JOINT REGIONAL PLANNING PANEL
(Sydney East Region)

| DA Number | 11/DA-21 REV03 |
| Proposed Development | Section 96(2) modification to Stage 2 of "East Quarter" development - addition of two (2) x storeys to buildings A, B & E, deletion of commercial floor space in Building B, associated facade and basement changes |

Assessment Report and Recommendation

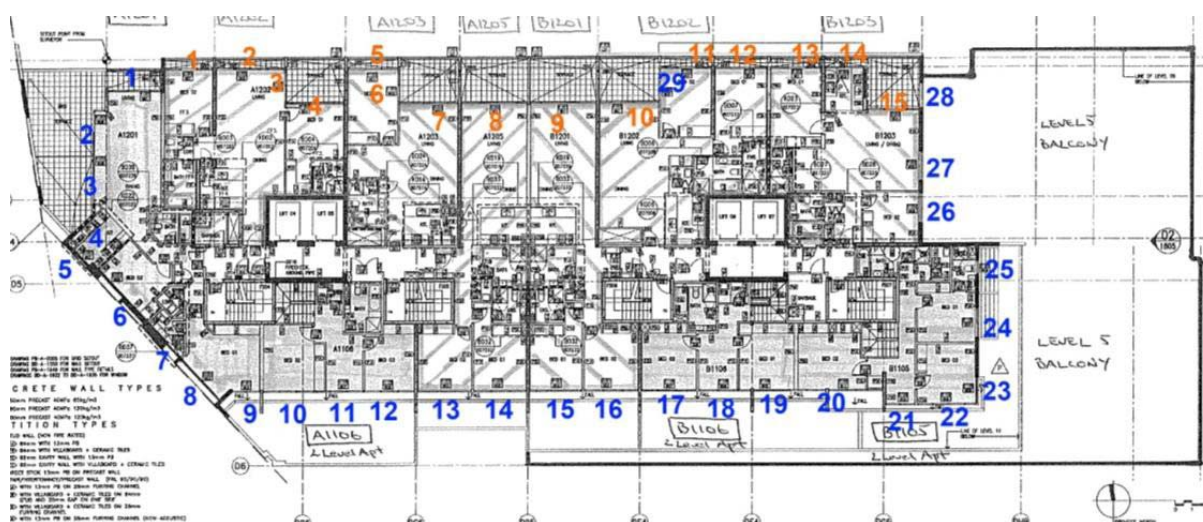
The applicant has also stated that the views to the east will be maintained, however this is incorrect as Building E located immediately east of Building D is already approved 4 storeys higher than Building D which would block the views in an easterly direction. Further to this any views obtained to the north east would be obstructed by the additional proposed height in Building A.

The primary view for units B1203 and B1204 on level 12 of Building D is towards the CBD skyline and this view would be totally lost. Whilst it is acknowledged that the views of the CBD are obtained over some distance, the city skyline Harbour Bridge and Sydney Tower can still be distinctively seen from Level 12 of Building D. The views currently obtained from these units are considered to be iconic.
